Statement of Compliance Access for People with a Disability

**2 – 8 Twin Creeks Drive,
Luddenham**

Report Type: Statement of Compliance
Development: 2 – 8 Twin Creeks Drive, Luddenham

PROPOSED ACCESSIBLE UNIT				
ACCESSIBLE ROOM	115	215	315	415
ACCESSIBLE ROOM	116	216	316	416
ACCESSIBLE ROOM	127	227	327	427
TOTAL	= 12 ROOMS

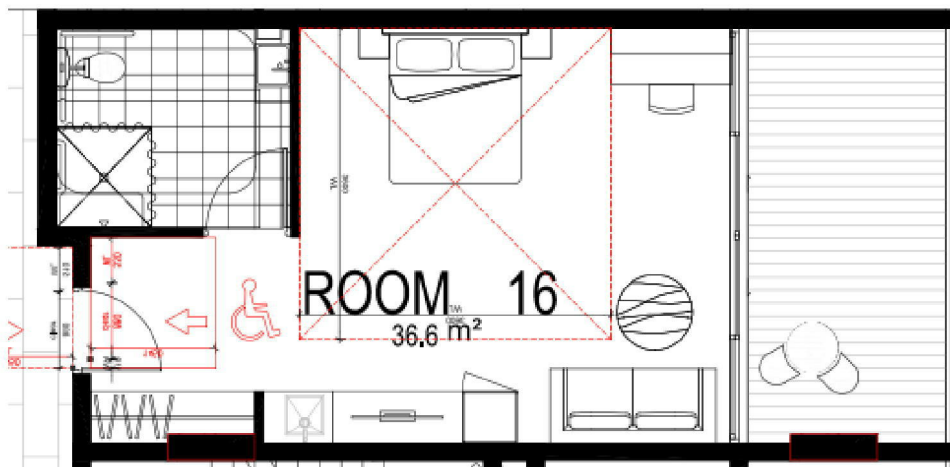
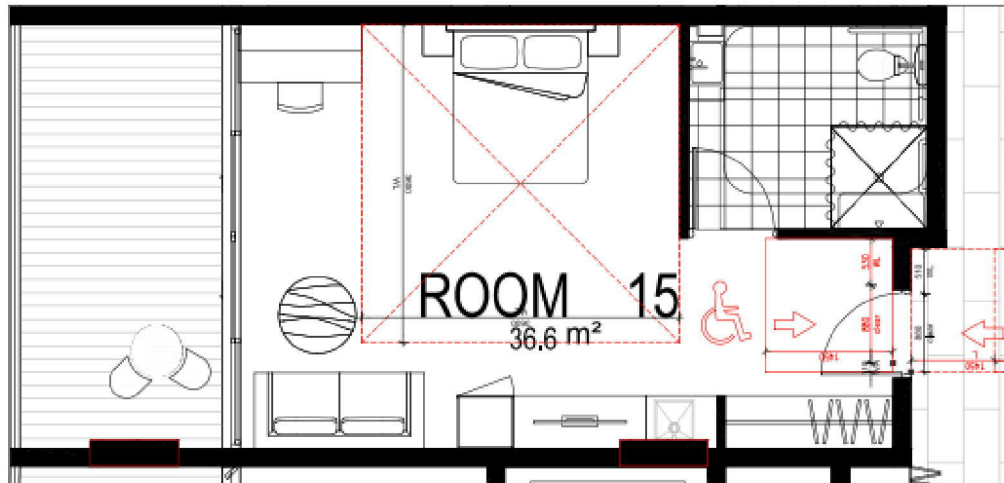
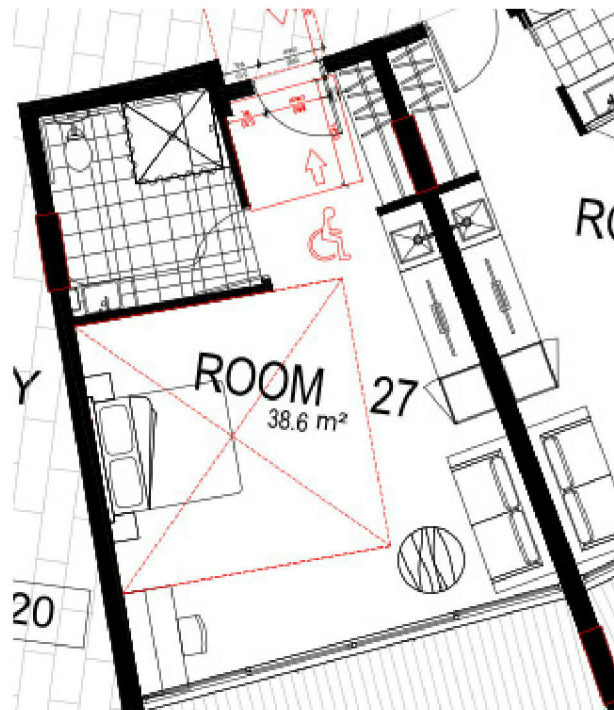
The 3 typical room designs have been shown.
An even number of LH and RH transfer bathrooms will be required for compliance.

At DA stage there is insufficient information to certify compliance with AS1428.1, however, in accordance with the table below, the units can comply with the spatial requirements of AS1428.1
